PLANNING CONSULTATION RESPONSE

Application No	2025/1062
Proposal	Demolition of existing domestic garage and formation of new driveway/parking, and outline permission for the erection of 4 houses within the residential garden
Address	Land adjacent to 1A West Street, Worsbrough Bridge, Barnsley, S70 5PG
Date of Consultation Reply	19/03/2026
Consultee	Claire Wilson, Planning Ecologist

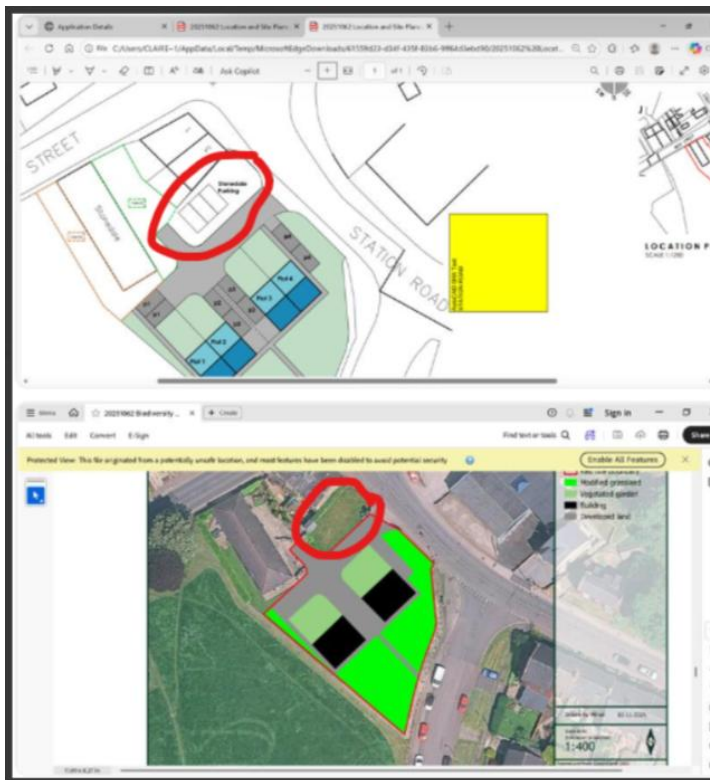
Areas currently mapped as parking on the Location and Site Plans have been excluded from the BNG assessment (see screenshot below). However, aerial imagery confirms that grassland is present within these areas and it is assumed this grassland will be lost to accommodate the parking. In addition, further sections of grassland and an existing building to the north fall within the red line boundary but have not been included within either the BNG assessment or the PEA. I seek clarification on this.

In accordance with government guidance (<https://www.gov.uk/guidance/understanding-biodiversity-net-gain>), all habitats within the red line boundary must be included within the baseline assessment.
